## Submission on publicly notified proposed district plan

- 1. This is a submission from Brett Osborne on the Proposed Lower Hutt District Plan 2025.
- 2. My email address for service is bretto.osborne@gmail.com.
- 3. I could not gain an advantage in trade competition through this submission.
- 4. The specific provisions of the proposal that my submission relates to, my submission on those provisions, and the decisions I seek are shown in the below table. I also seek all further, alternative, necessary, or consequential relief as may be necessary to fully achieve the relief sought in this submission.
- 5. I do not wish to be heard in support of my submission.
- 6. If others make a similar submission, I will not consider presenting a joint case with them at the hearing.

| 1 | Maps | Flood Hazard Overlay | Support with | Holmes Grove is a cul de sac                 | It is requersted the Low and Medium    |

**Extract B:** Photographs of retaining wall and raised ground level of 13 Holmes Grove above the road reserve. Each half round is approximately 150mm high.

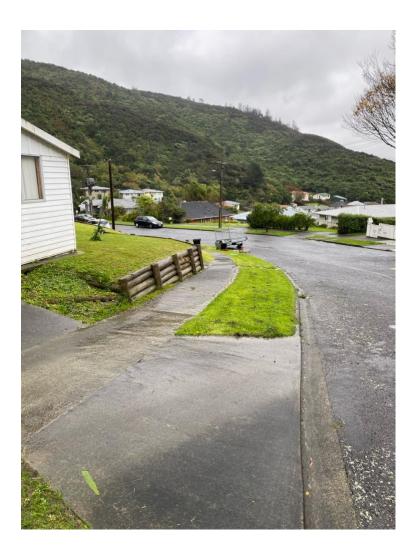
| 1 | Maps | Flood Hazard Overlay | Support with | Holmes Grove is a cul de sac                 | It is requersted the Low and Medium    |
|---|------|----------------------|--------------|--|--|
|   |      |                      |              | <b>Extract B</b> shows photographs of the    |  |
|   |      |                      |              | subject areas where there is an              |  |
|   |      |                      |              | existing retaining wall along the            |  |
|   |      |                      |              | frontage of 13 Holmes Grove. This            |  |
|   |      |                      |              | ranges approximately 0.5m to 1.0m            |  |
|   |      |                      |              | high above the road reserve.                 |  |

Extract C: WWL flood model and depth.

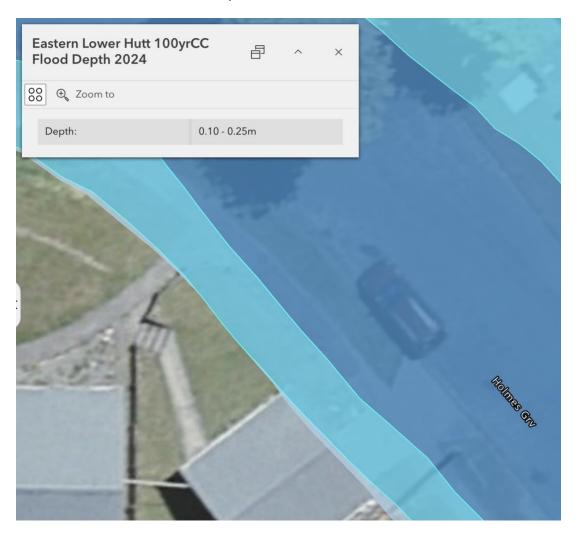
| 1 | Maps | Flood Hazard Overlay | Support with | Holmes Grove is a cul de sac                 | It is requersted the Low and Medium    |
|---|------|----------------------|--------------|--|--|
|   |      |                      |              | The online WWL flood model <sup>1</sup> and  |  |
|   |      |                      |              | the associated technical report <sup>2</sup> |  |
|   |      |                      |              | clarifies the model flood depth as           |  |
|   |      |                      |              | 0.1m to 0.25m (see extract C). That          |  |
|   |      |                      |              | overlay area is applied uniformly            |  |
|   |      |                      |              | across the subject area and                  |  |
|   |      |                      |              | therefore does not account for that          |  |

| # | Chapter | Provision | Position | Reasons                             | Relief sought |
|---|---------|-----------|----------|-------------------------------------|---------------|
|   |         |           |          | area being approximately 0.5m to    |               |
|   |         |           |          | 1.0m <u>above</u> the road reserve. |               |

| # | Chapter | Provision | Position | Reasons                             | Relief sought |
|---|---------|-----------|----------|-------------------------------------|---------------|
|   |         |           |          | It is therefore requested the flood |               |
|   |         |           |          | hazard overlay be amended to        |               |
|   |         |           |          | exclude it extending into the       |               |
|   |         |           |          | property of 13 Holmes Grove.        |               |

**Extract D:** Flood model depth within road reserve.

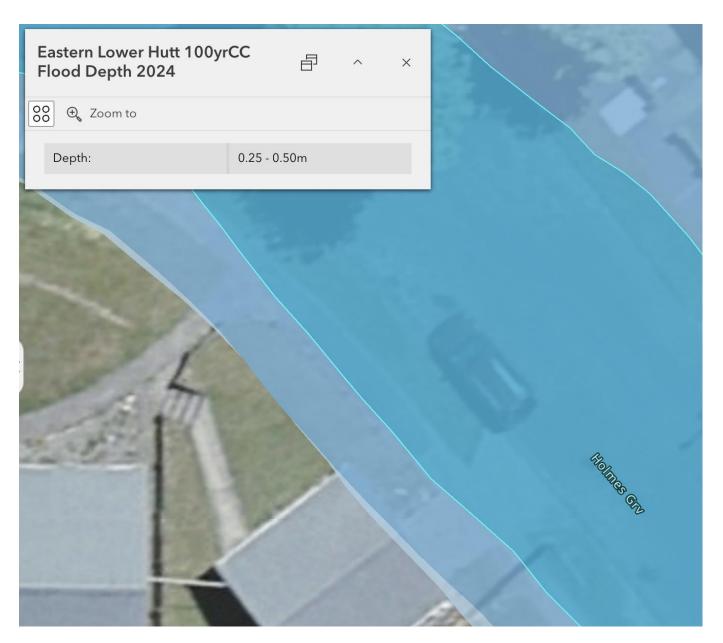
| # | Chapter | Provision | Position | Reasons                             | Relief sought |
|---|---------|-----------|----------|-------------------------------------|---------------|
|   |         |           |          | further context, the modelled flood |               |
|   |         |           |          | depth within the road reserve is    |               |
|   |         |           |          | 0.25 to 0.5m deep. As such, it      |               |
|   |         |           |          | would not extend into the subject   |               |
|   |         |           |          | site (see <b>extract D</b> ).       |               |
